**Re: 22-32 Junction St, Forest Lodge Flood Assessment**

## PLANNING PROPOSAL REQUEST – 2-32 JUNCTION STREET, FOREST LODGE

I refer to your submission of a revised planning proposal request to amend the maximum height and floor space ratio controls under Sydney LEP 2012 and draft planning agreement offer for 2-32 Junction Street, Forest Lodge.

# PLANNING PROPOSAL AMENDMENT REPORT

# SEPP-65 COMPLIANCE (1B) (EXISTING CONDITION):

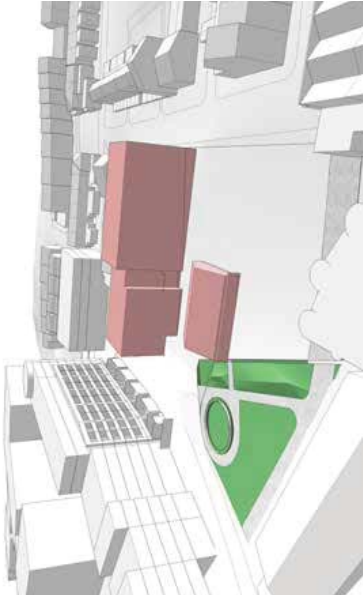
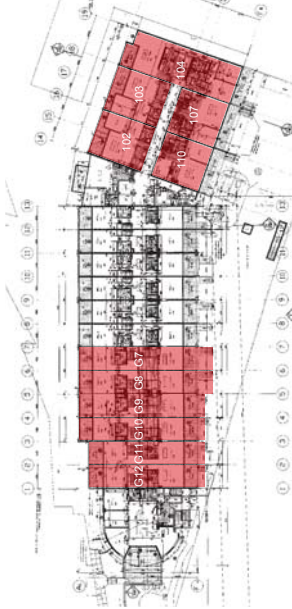
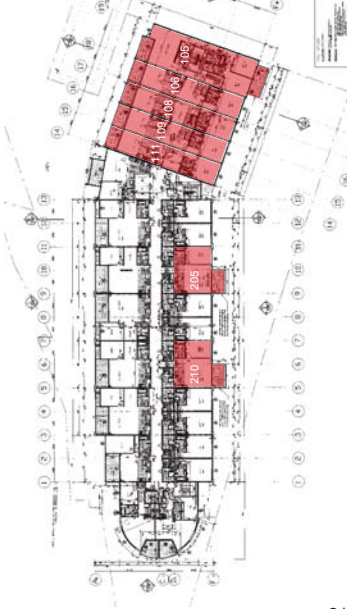
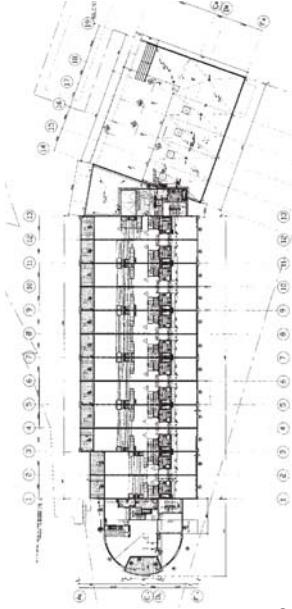
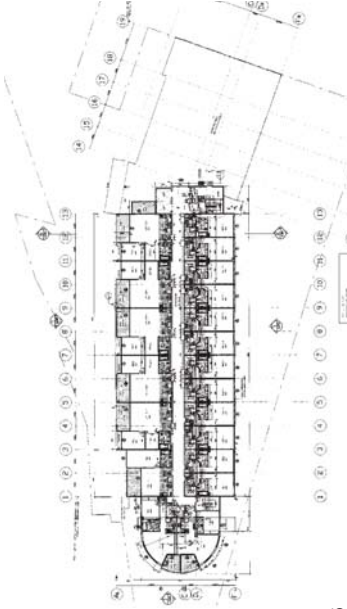
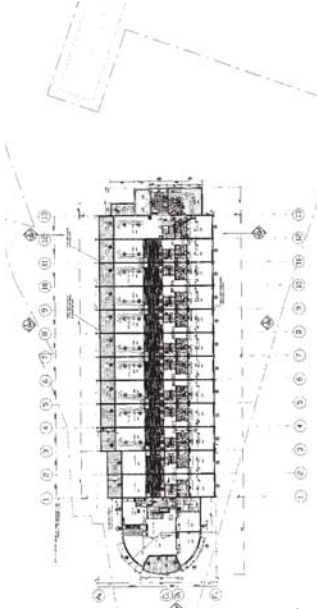
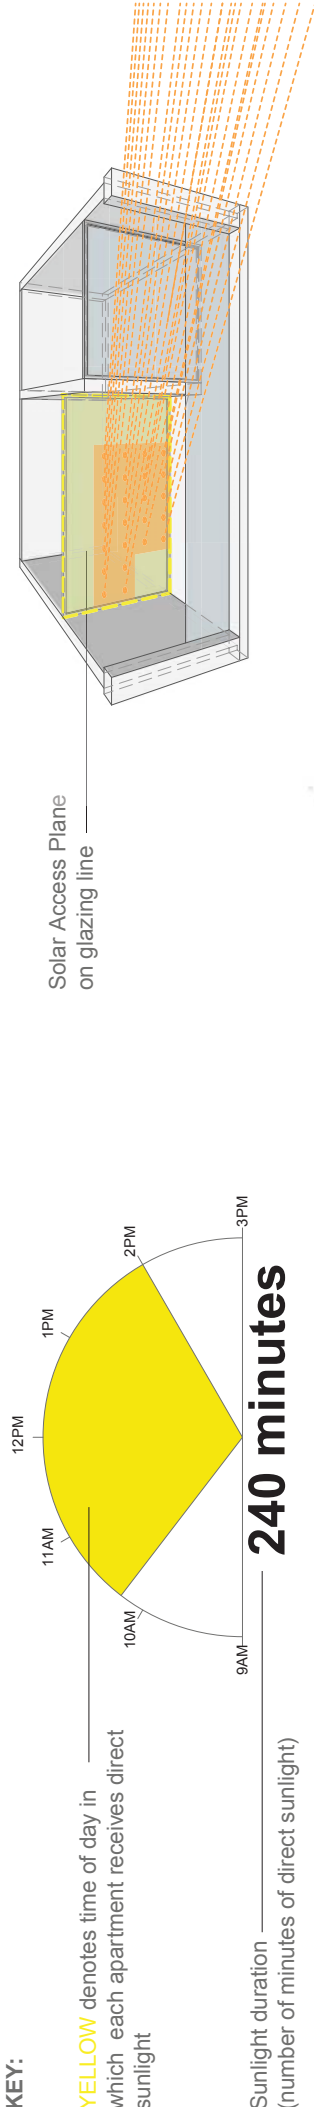
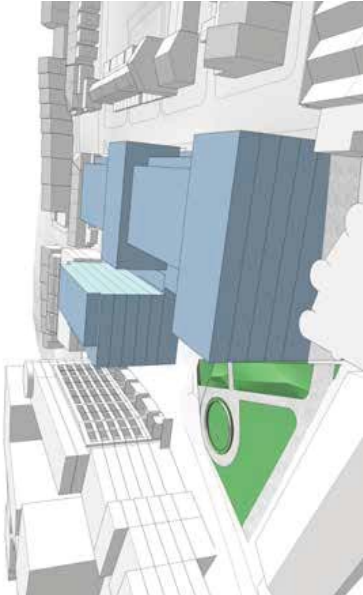
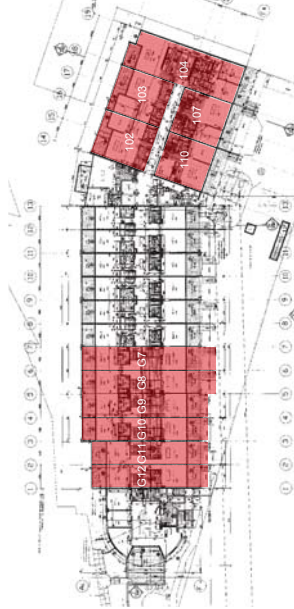
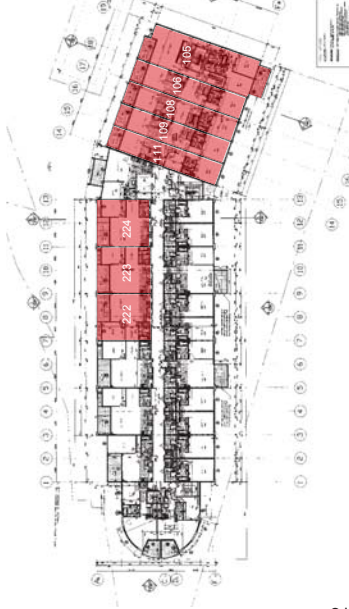
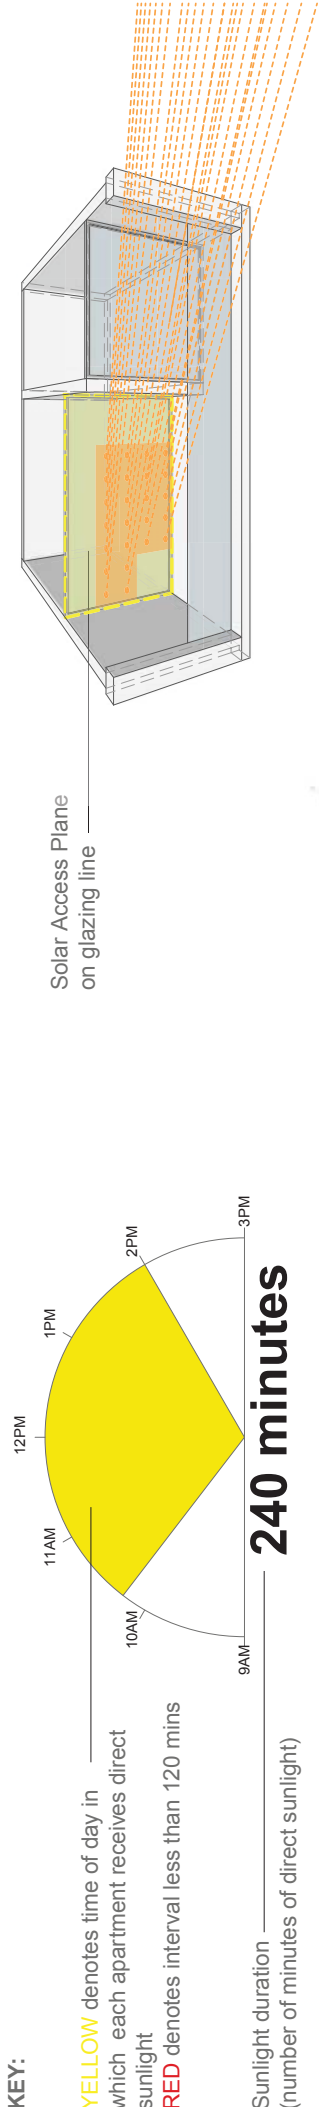
The overshadowing analysis provided indicates 70% of apartments will receive at least 2 hours of sunlight on the vertical plane, however, it does not say whether the sunlight is at least 1m<sup>2</sup> in area on the vertical plane, 1 metre above the floor level and received for at least 15 minutes.

The overshadowing analysis states there are currently more than 15% of units that receive no direct sunlight (27.5%) and the proposal will increase that number of units. However, the analysis has been undertaken on the horizontal rather than vertical plane and therefore compliance cannot be determined.

For the planning proposal to progress, the overshadowing analysis will need to demonstrate the proposal can comply with the Apartment Design Guide, including Parts 3B and 4A, using the methodology outlined above.

OVERSHADOWING OF NEIGHBOURING PARK

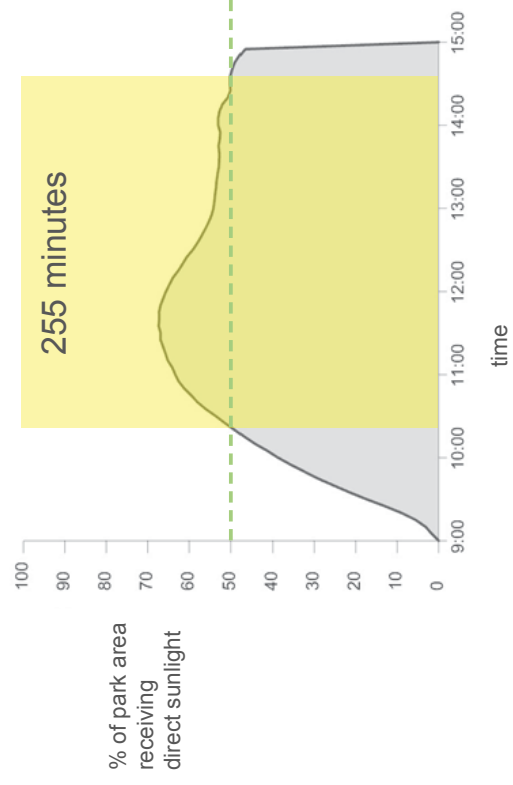
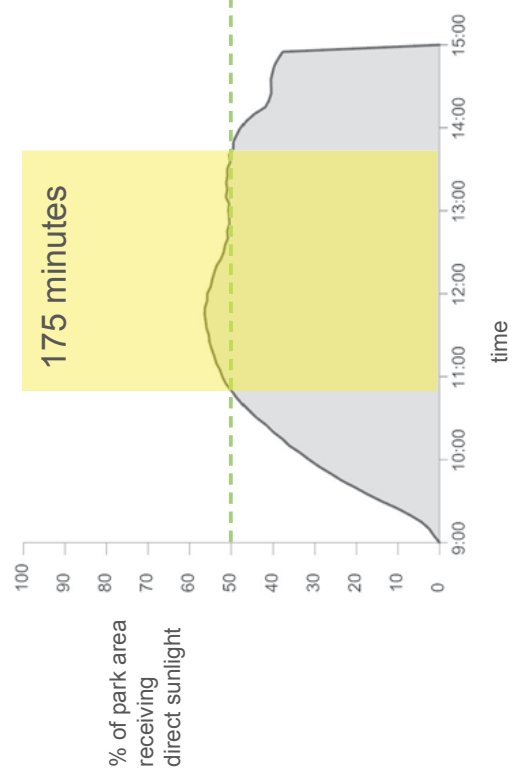
Building D is considered to have an unacceptable impact on Larkin Street Reserve due to its height, scale, bulk, proximity and its carpark use. The sections provided do not correlate with the survey and do not show the building heights and walls along the Reserve and side boundaries accurately.

For the planning proposal to progress, the proposal will need to be amended to reduce the impact of Building D on Larkin Street Reserve by increasing the setback of Building D from the extended boundary of the reserve and introducing upper level setbacks. Accurate plans, elevations, sections and a 3D massing model are to be submitted illustrating the relationship of the built form to the surrounding area.

# MASSING REVISIONS

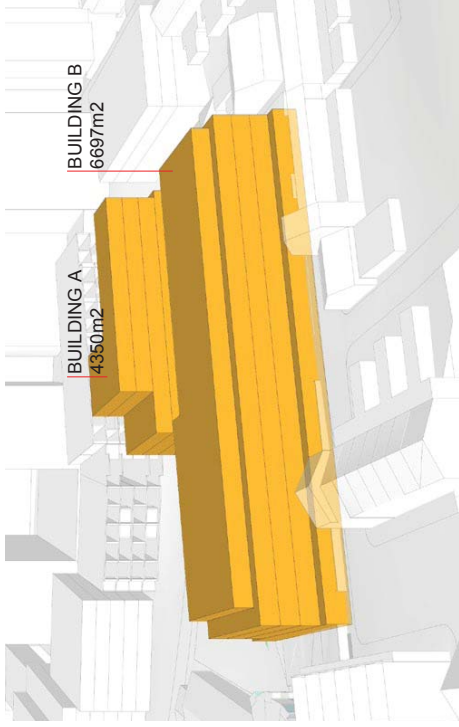
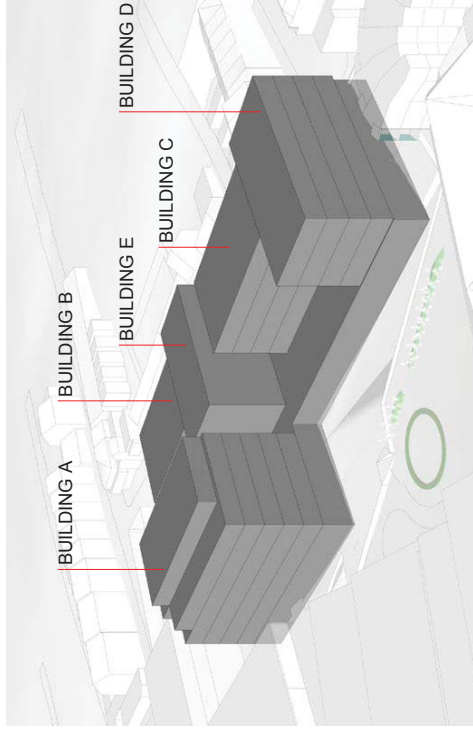
The proposal needs to comply with Part 3F of the ADG. In particular, typical floor plans need to be provided showing the side setbacks between habitable and non-habitable rooms. This includes Buildings A, B and D. If typical floor plans are not provided, it will be assumed the rooms with windows facing the side boundaries are habitable. In this case, rooms with windows on levels above 12 metres need to be setback at least 9 metres from the side boundaries. Alternatively, if typical floor plans are provided indicating rooms on levels above 12 metres are non-habitable, the rooms need to be setback at least 4.5 metres. Where the basement car park protrudes more than 3 metres above ground level, it will be considered as a storey.

- (A) 1.5m setback on Levels 4-6 of Building A and Level 4 of Building B (to satisfy Apartment Design Guide 3F)
- (B) L-shaped massing form on top two levels of Building A in order to ensure solar access to Larkin Street apartments includes 2-metre circulation zone on Level 5 for access to two-storey apartments
- (C) Increase length of Building A (Levels 1-4) by 8m towards Larkin Street Reserve
- (D) Demolish Building E, remove mid through-site link and consolidate Buildings B, C and D into one massing form (with articulation)
- (E) Setbacks to southern elevation of new Building B (formerly D) to ensure adequate solar access to townhouses at 2A Short Street (1.5m setbacks for Levels 1-3, and 5m setback for Level 4)
- (F) Increase width of Building C by 3.5m (from 18.5m to 22m). The 22m width includes a glass line to glass line dimension of 18m, and a balcony zone on both sides.

# LARKIN STREET APARTMENTS SUNLIGHT ACCESS

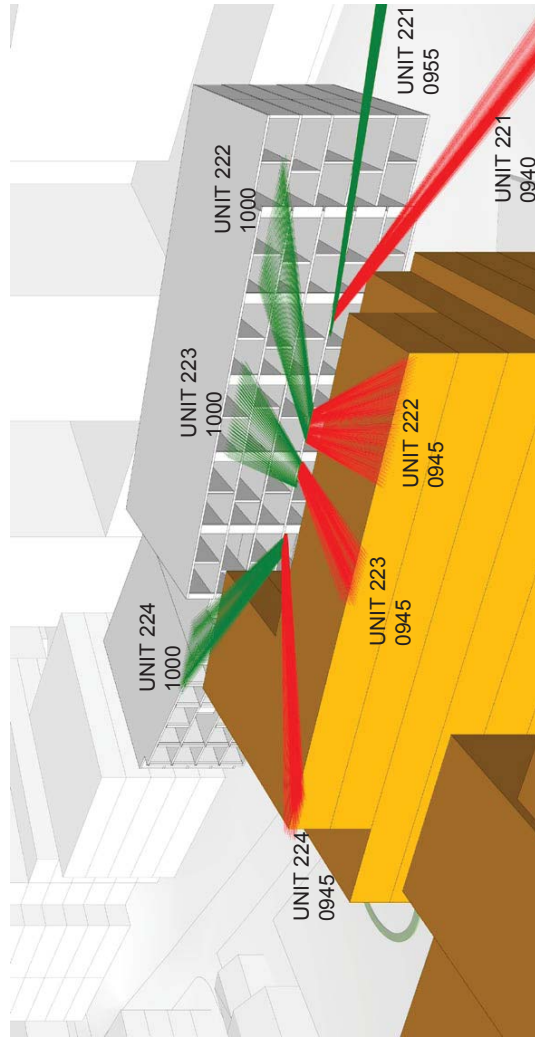
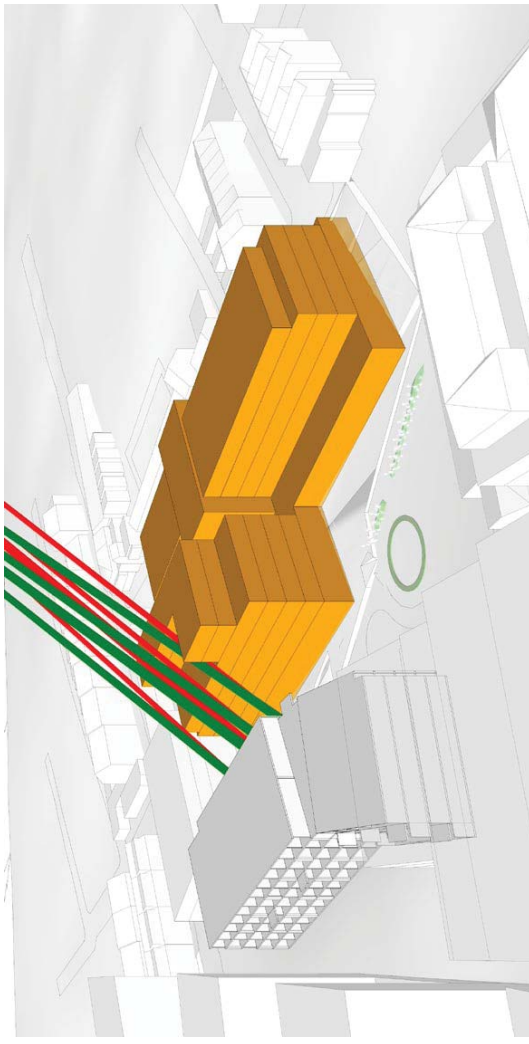
The proposal need to comply with Parts 3B and 4A of the Apartment Design Guide. In particular, the proposal needs to ensure at least 70% of apartments in neighbouring buildings receiving 2 hours or more of sunlight. Additionally, the apartments that receive less than 2 hours cannot have their sunlight reduced to less than 15 minutes measured on the horizontal plane 1 metres above the floor level. Under the current scheme, the number of apartments receiving 2 hours or more is reduced to 70% and the number of apartments receiving no sunlight (measured on the horizontal plane) is increased by 3 apartments from 27.5% of apartment to approximately 30% of apartments. The proposal needs to be amended so the 3 apartments receive at least 15 minutes of sunlight measured on the horizontal plane.

These raytracing diagrams illustrate how setbacks in Level 5 and Level 6 of Building A permit solar access to Units 221-224 at 1-3 Larkin Street such that these apartments comply with the Design Guideline in the Apartment Design Guide:

Specifically Unit 221 receives 1 sqm of direct sunlight for 15 minutes (from 9:40am to 9:55 am) and Units 222-224 receive 1 sqm of direct sunlight for 15 minutes (from 9:45am to 10:00 am).

# SHORT STREET TOWNHOUSES SUNLIGHT ACCESS

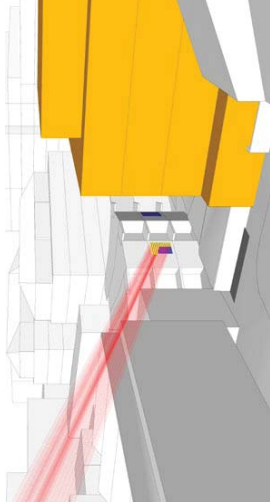
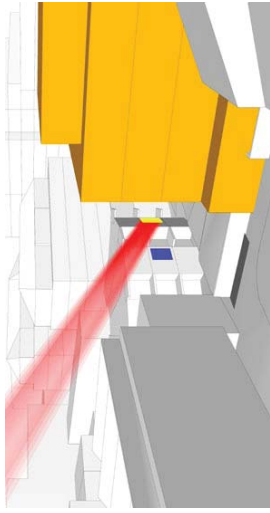
For the planning proposal to progress, an assessment of the proposed scheme's overshadowing impact at 2A Short Street and its compliance against the Apartment Design Guide will need to be provided.

Two townhouses are impacted by the proposed development: 7/2A and 8/2A Short Street. These raytracing diagrams illustrate how the living spaces of 7/2A and 8/2A Short Street receive 2.5 hours of direct sunlight between 9 and 11:30am at the winter solstice, and thus comply with Objective 4A-1 of the Australian Design Guide:
